No. 1009
ATA Code 23-60

Kit No. 76-5001-1 S

- SUBJECT:** COMMUNICATIONS - INSTALLATION OF STATIC DISCHARGE WICKS
- EFFECTIVITY:** BEECHCRAFT Duchess 76, serials ME-4, ME-5, ME-6 and ME-9 through ME-79.
- REASON:** To provide improved discharge of static electricity by installing static discharge wicks.
- COMPLIANCE:** At the owner's discretion, however, Beech Aircraft Corporation recommends that this be accomplished at the next scheduled inspection.
- APPROVAL:** FAA Approved - DOA CE-2.
- MANPOWER:** The following information is for planning purposes only:

Service Instructions No. 1009

Figure 1.

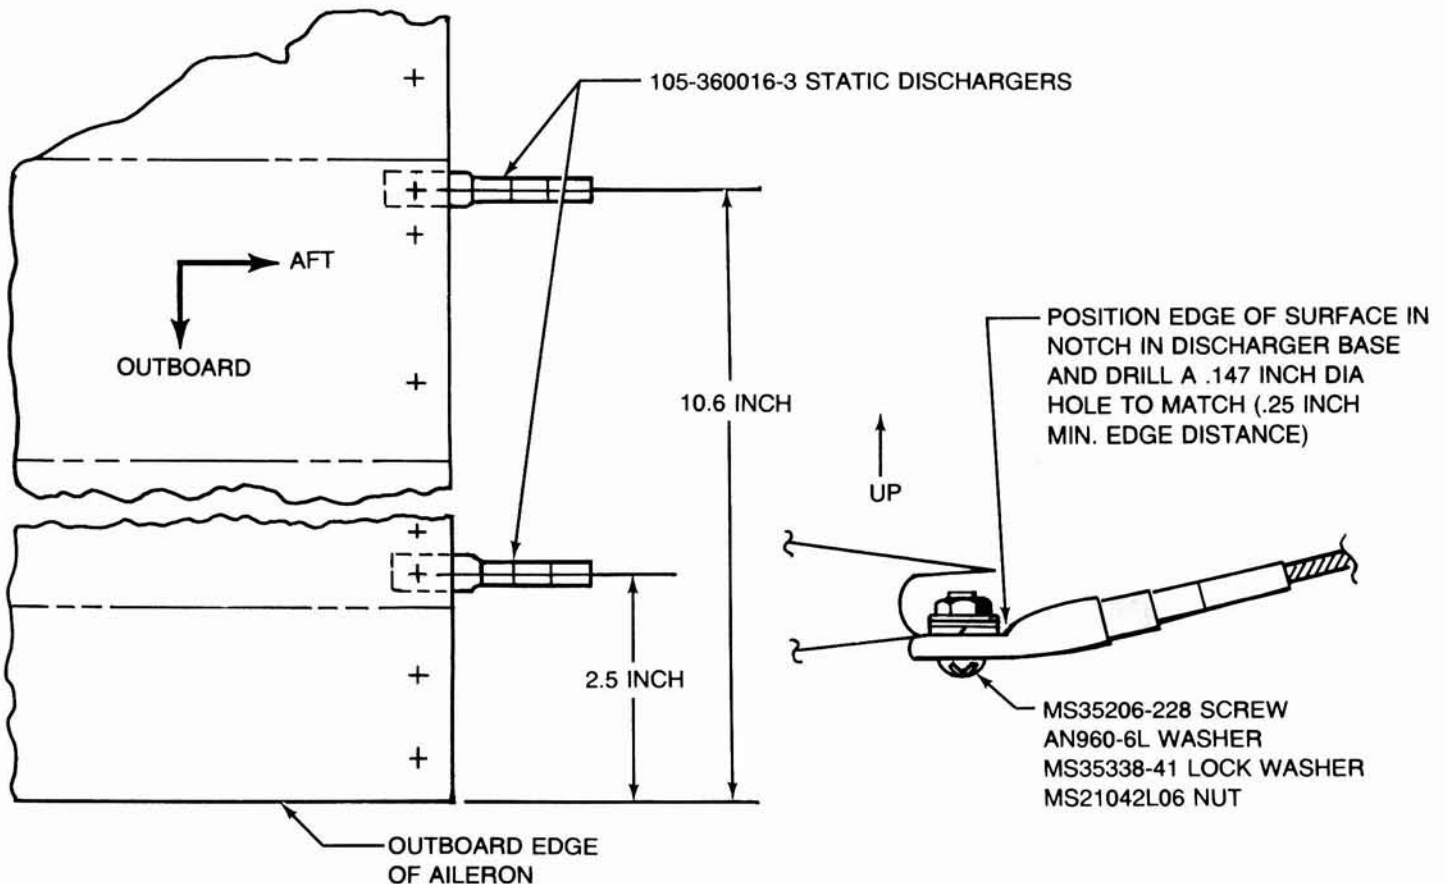
2. Drill out one rivet where each static discharger will be installed and drill the hole out to .147 inch diameter.

3. Remove all paint or other protective coating from an area on the underside of the aileron trailing edge just large enough to accommodate one static discharger at each location shown in Figure 1.

5. Install a P/N 105-360016-3 static discharger at each location as shown in Figure 1. Touch up paint as required around the static dischargers. The metal base and the mounting bolt may be painted but do not paint the static discharger wicks.

Figure 2.

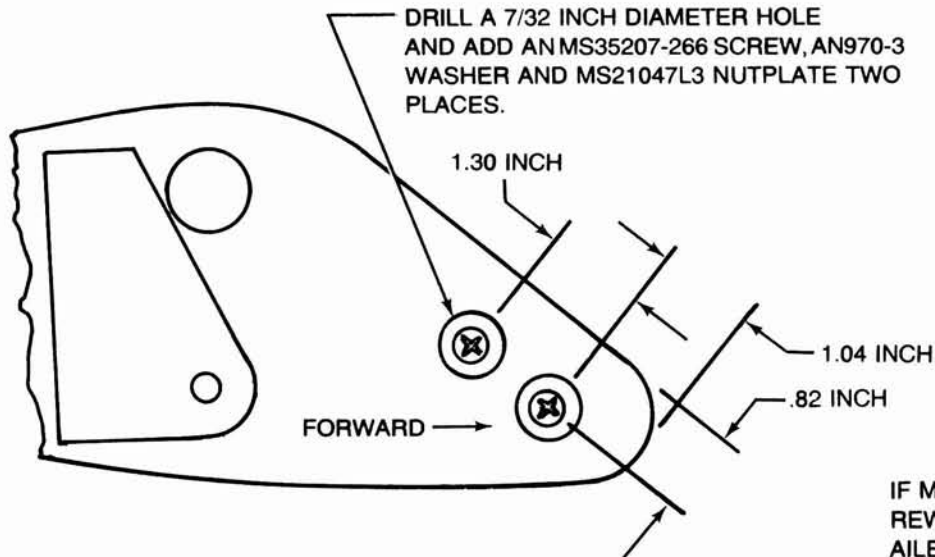
6. Refer to the Duchess 76 Maintenance Manual, Chapter 57-50 and balance the aileron. A total of five P/N 115-610010-123 weights may be installed on each of the two screws on the outboard end of the aileron. Additional weights, if required, may be added to the inboard end of the aileron (see Figure 2.).

IF MORE WEIGHT IS REQUIRED REWORK THE INBOARD END OF THE AILERON AS SHOWN. A MAXIMUM OF FIVE P/N 115-610010-123 WEIGHT MAY BE USED ON EACH SCREW.

Figure 3.

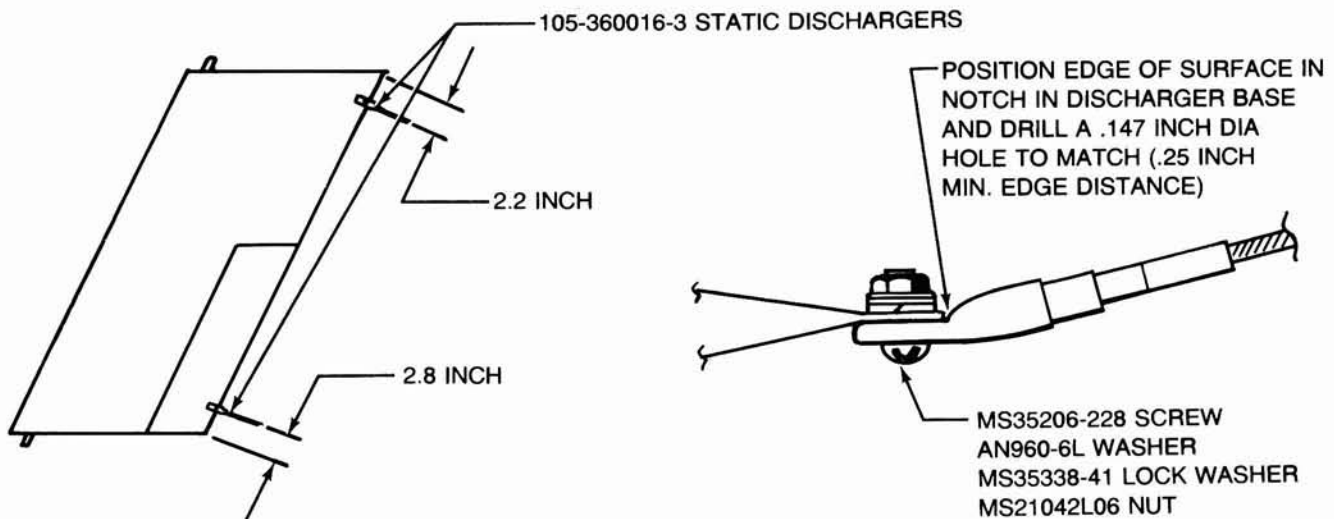
11. Drill a .147 inch diameter hole at each location shown in Figure 3.
12. Remove all paint or other protective coating from the areas where the static dischargers will be installed.

13. Clean and treat the area around the holes as described in step 4.
14. Install one P/N 105-360016-3 static discharger at each location shown in Figure 3. Touch up paint as required around the static dischargers. The metal base and the mounting bolt may be painted but do not paint the static discharger wicks.
15. Refer to the Maintenance Manual, Chapter 55-40 and balance the rudder. A total of five P/N 105-630012-3 weights may be installed on the rudder. Install the weights, if required, with NAS1738B4-3 rivets.

Figure 4.

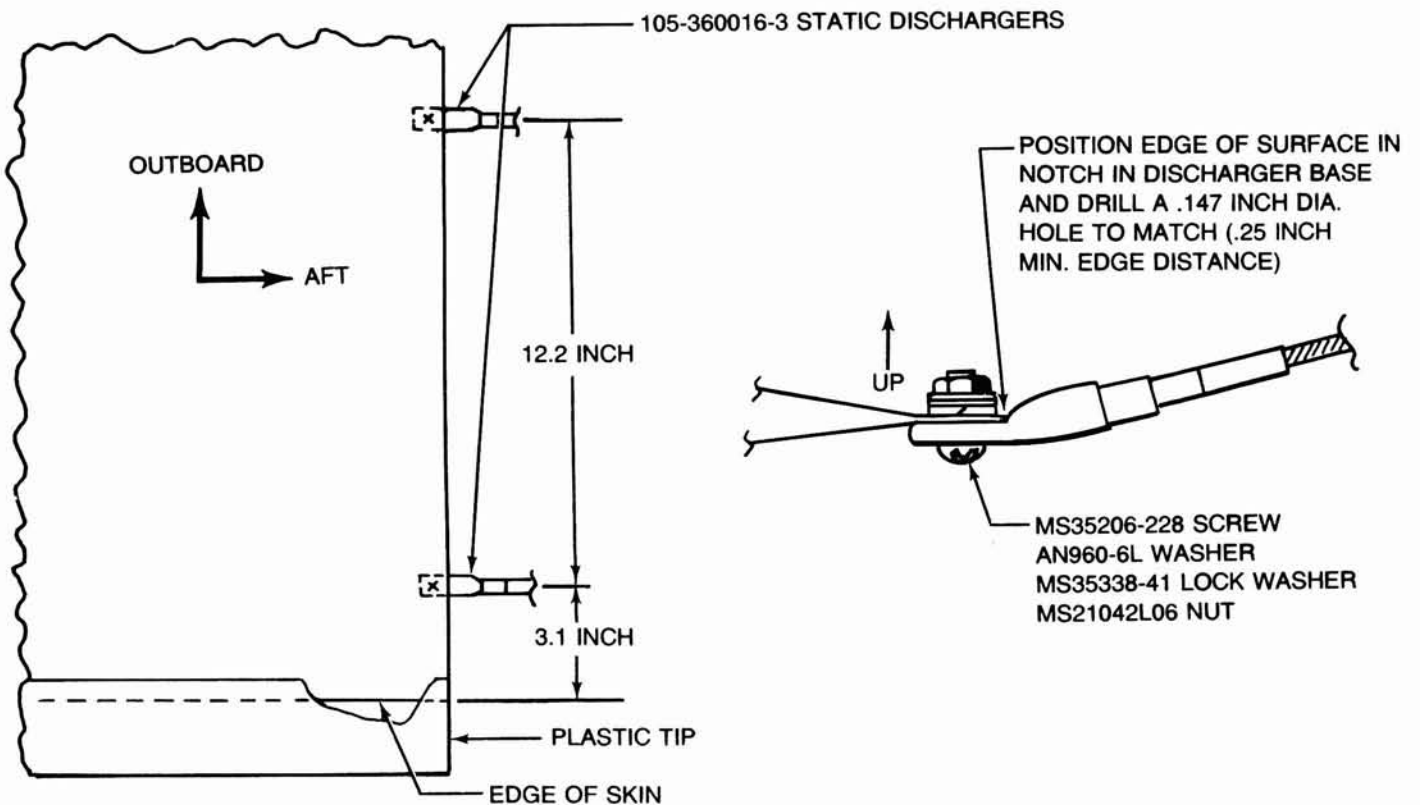
19. Drill a .147 inch diameter hole at each location shown in Figure 4.

22. Install one P/N 105-360016-3 static discharger at each location as shown in Figure 4. Touch up paint as required around the static dischargers. The metal base and the mounting bolt may be painted but do not paint the static discharger wicks.

Figure 5.

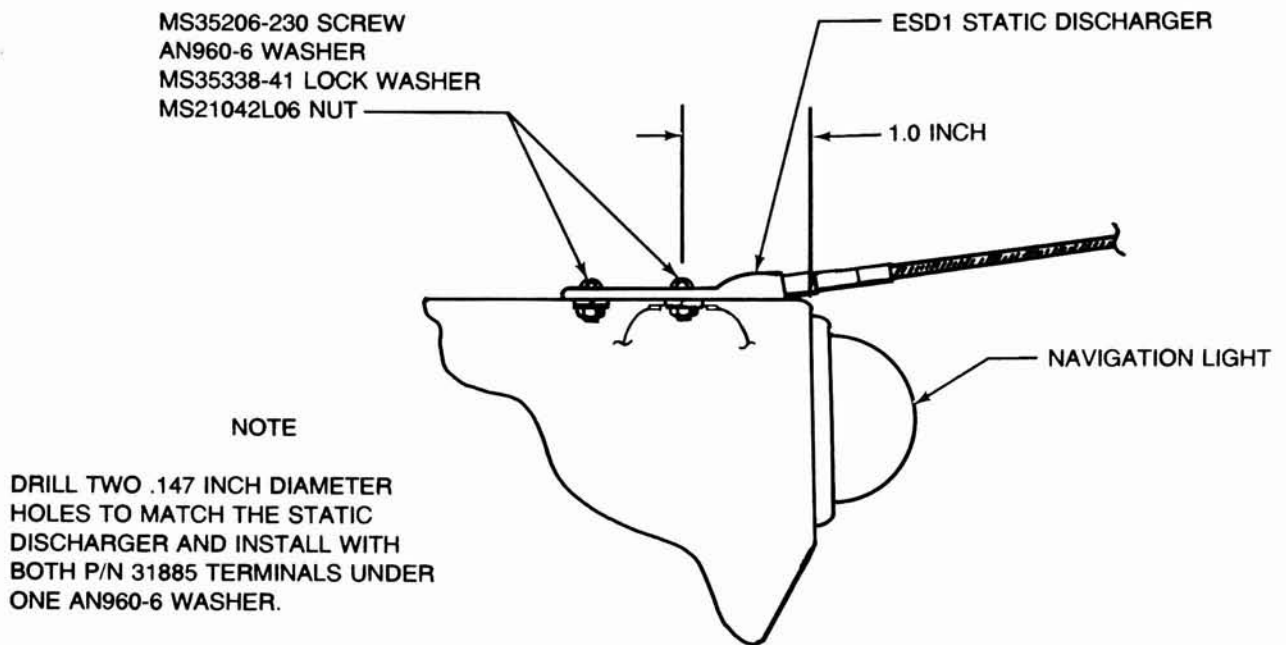
25. Remove the navigation light from the fairing which was removed in step 17.
26. Position the P/N ESD1 static discharger on the fairing as shown in Figure 5 and drill two .147 inch diameter holes in the fairing to match the static discharger.
27. Cut the navigation light ground wire (wire number L11B20) approximately three inches from the navigation light and install a P/N 31885 terminal on each cut end.

28. Install the ESD1 static discharger on the fairing as shown in Figure 5 and reinstall the navigation light in the fairing.
